SALEM NUCLEAR GENERATING STATION, UNIT NO. 1

AMENDMENT TO FACILITY OPERATING LICENSE

Amendment No. 52  
License No. DPR-70

SALEM NUCLEAR GENERATING STATION, UNIT NO. 2

FIGURE 2.1-1 REACTOR CORE SAFETY LIMIT - FOUR LOOPS IN OPERATION

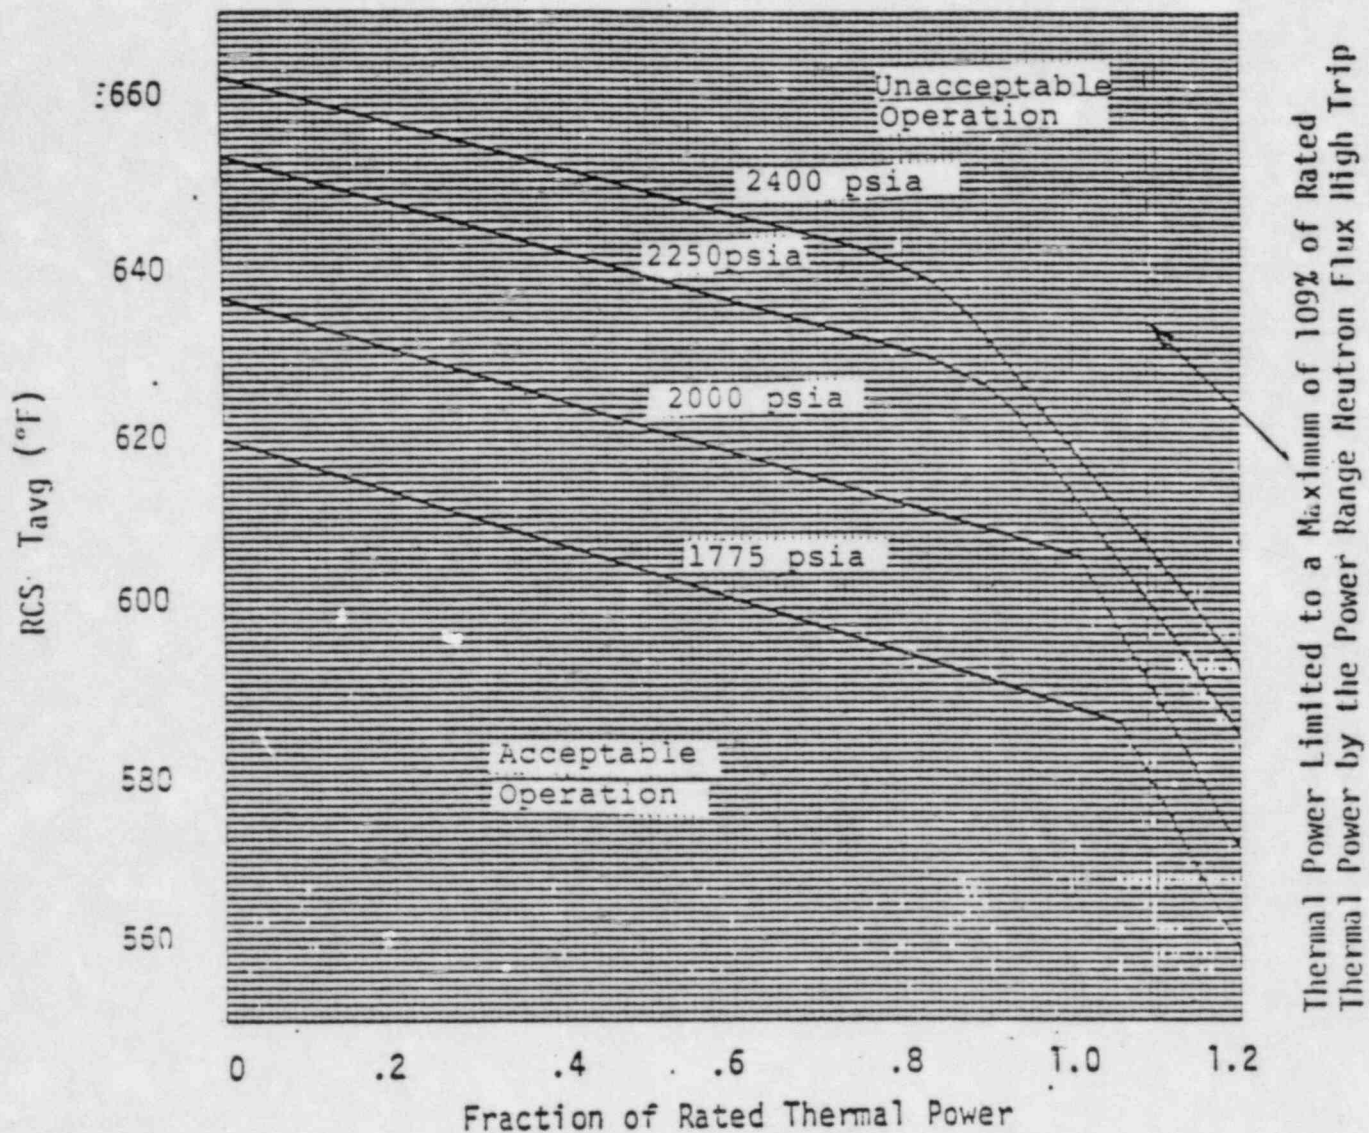
2-2

2-2

The curves are based on an enthalpy hot channel factor,  $F_{\Delta H}^N$ , of 1.55 and a reference cosine with a peak of 1.55 for axial power shape. An allowance is included for an increase in  $F_{\Delta H}^N$  at reduced power based on the expression:

$$F_{\Delta H}^N = 1.55 [1 + 0.3 (1-P)]$$

Figure 3.2-3  
RCS TOTAL FLOWRATE VERSUS R — FOUR LOOPS  
IN OPERATION

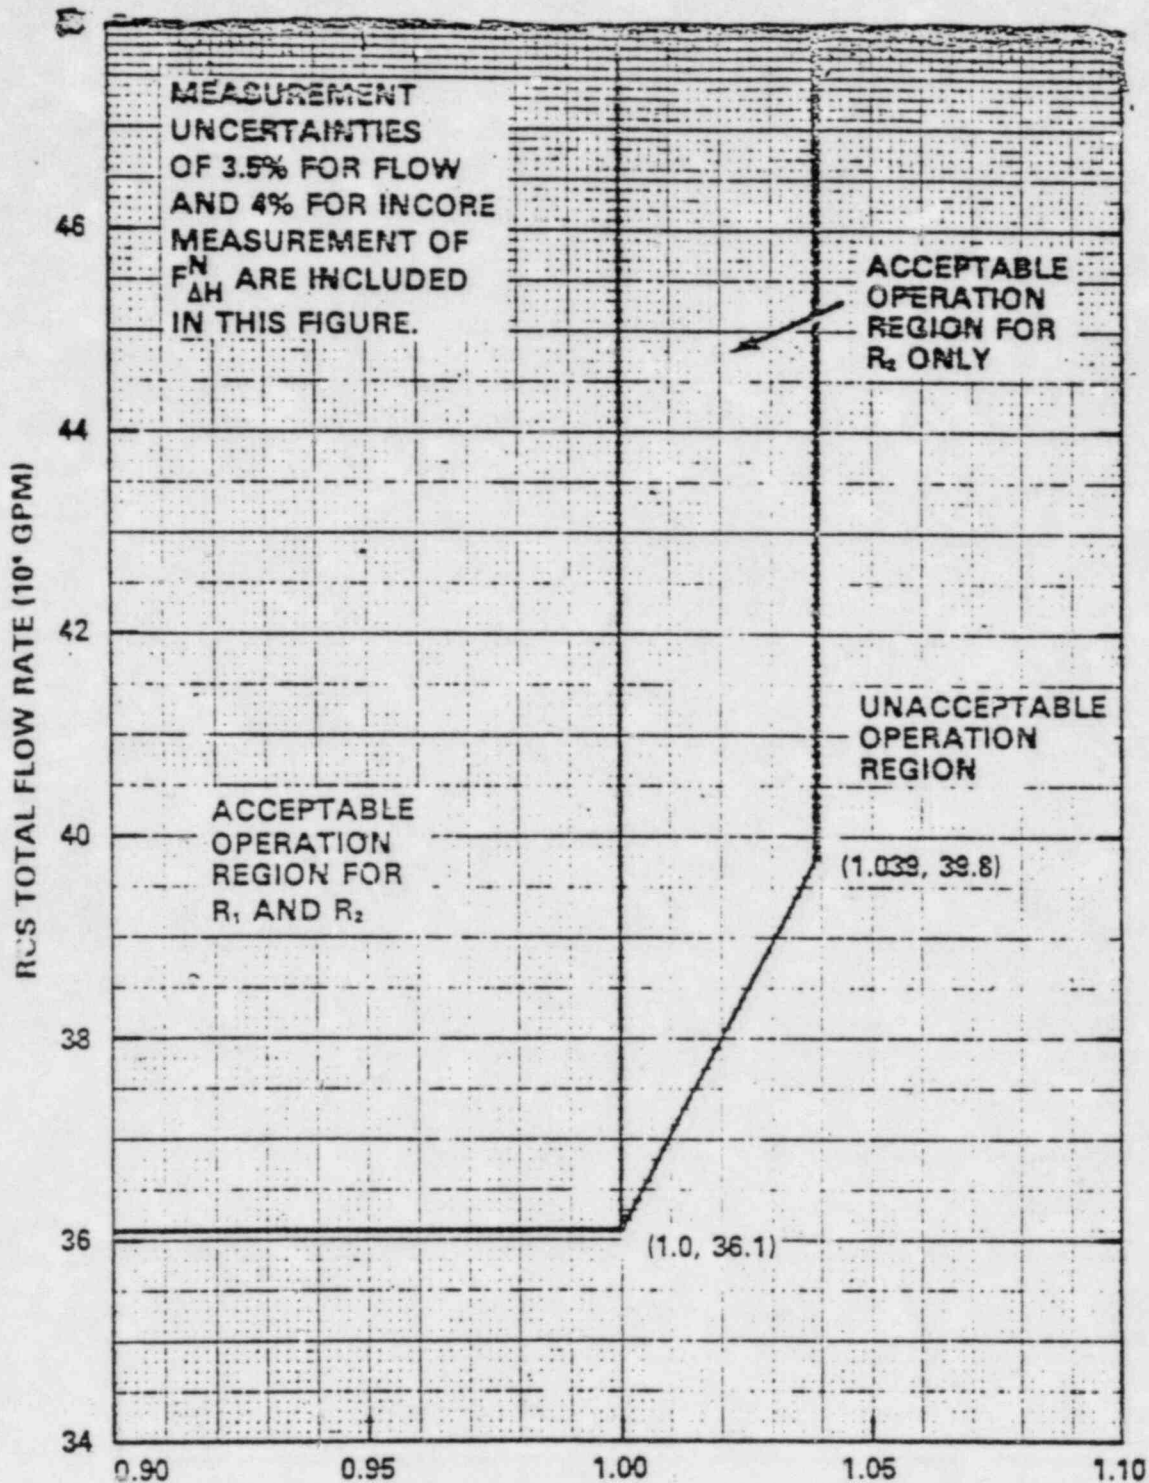
3/4 2-11

3/4 2-11

3.2.3 The combination of indicated Reactor Coolant System (RCS) total flow rate and  $R_1$ ,  $R_2$  shall be maintained within the region of allowable operation shown on Figure 3.2-3 for 4 loop operation.

- a.  $R_1 = \frac{F_{\Delta H}^N}{1.49 [1.0 + 0.3 (1.0 - P)]}$ ,
- b.  $R_2 = \frac{R_1}{[1 - RBP(BU)]}$ ,
- c.  $P = \frac{\text{THERMAL POWER}}{\text{RATED THERMAL POWER}}$ , and
- d.  $F_{\Delta H}^N$  = Measured values of  $F_{\Delta H}^N$  obtained by using the movable incore detectors to obtain a power distribution map. The measured values of  $F_{\Delta H}^N$  shall be used to calculate R since Figure 3.2-3 includes measurement uncertainties of 3.5% for flow and 4% for incore measurement of  $F_{\Delta H}^N$ .
- e. RBP (BU) = Rod Bow Penalty as a function of region average burnup as shown in Figure 3.2-4, where a region is defined as those assemblies with the same loading date (reloads) or enrichment (first core).

$$R_1 = F_{\Delta H}^N / 1.49 [1.0 + 0.3 (1.0 - P)]$$

$$R_2 = R_1 / [1 - RBP(BU)]$$

FIGURE 2.1-1 REACTOR CORE SAFETY LIMIT - FOUR LOOPS IN OPERATION

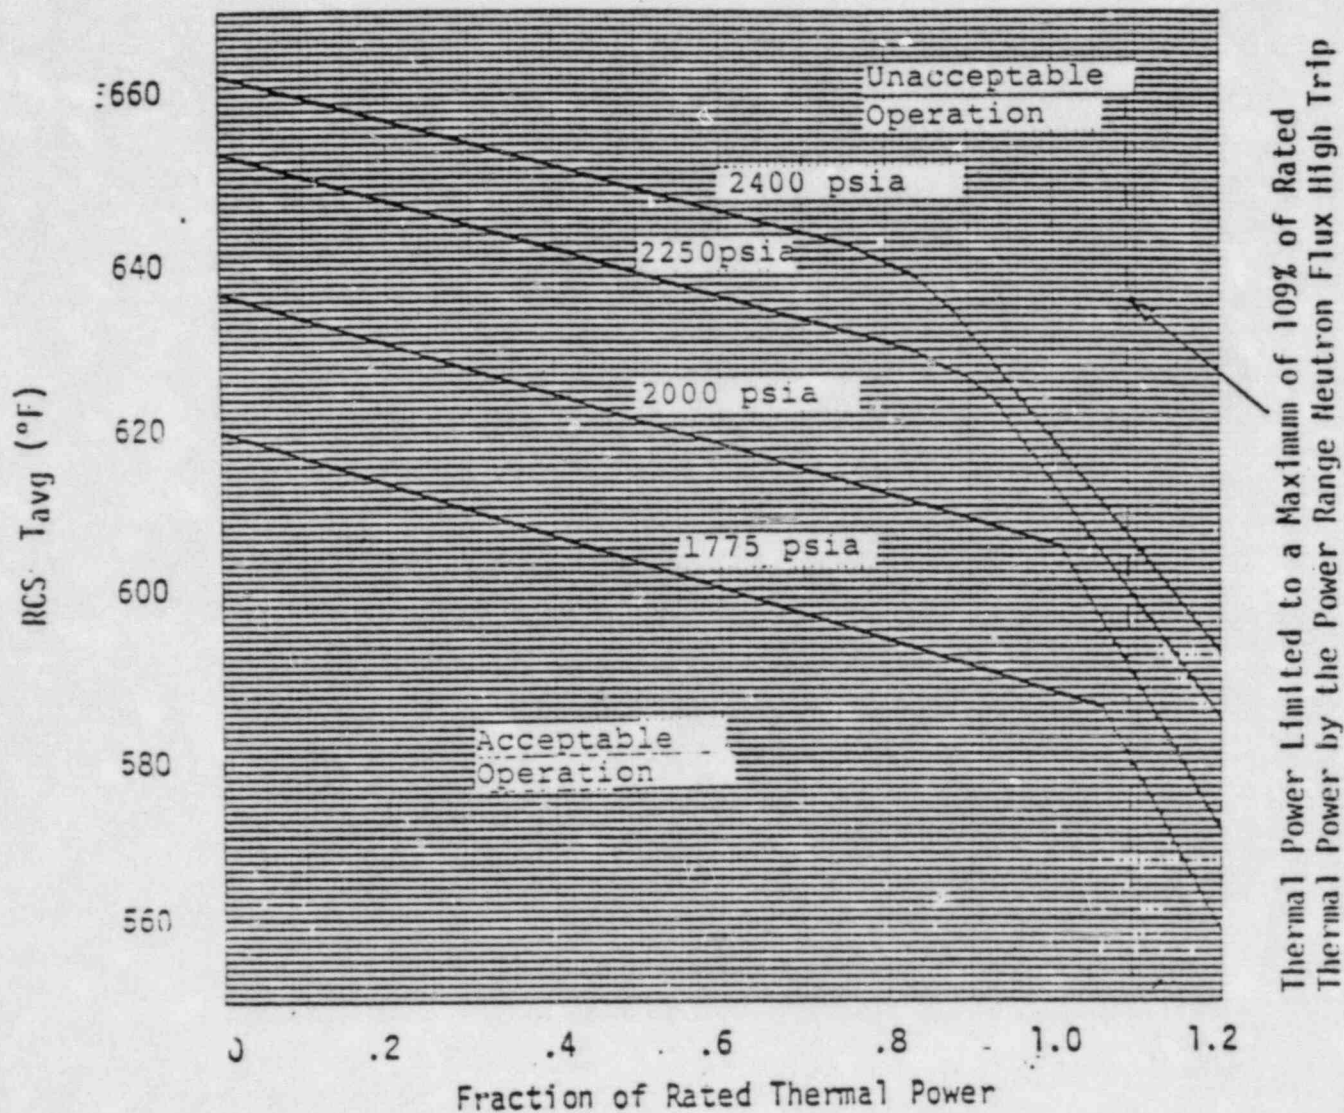
2-2

2-2

The curves of Figures 2.1-1 and 2.1-2 show the loci of points of THERMAL POWER, Reactor Coolant System pressure and average temperature for which the minimum DNBR is no less than 1.30, or the average enthalpy at the vessel exit is equal to the enthalpy of saturated liquid.

The curves are based on an enthalpy hot channel factor,  $F_{\Delta H}^N$ , of 1.55 and a reference cosine with a peak of 1.55 for axial power shape. An allowance is included for an increase in  $F_{\Delta H}^N$  at reduced power based on the expression:

$$F_{\Delta H}^N = 1.55 [1 + 0.3(1-P)]$$
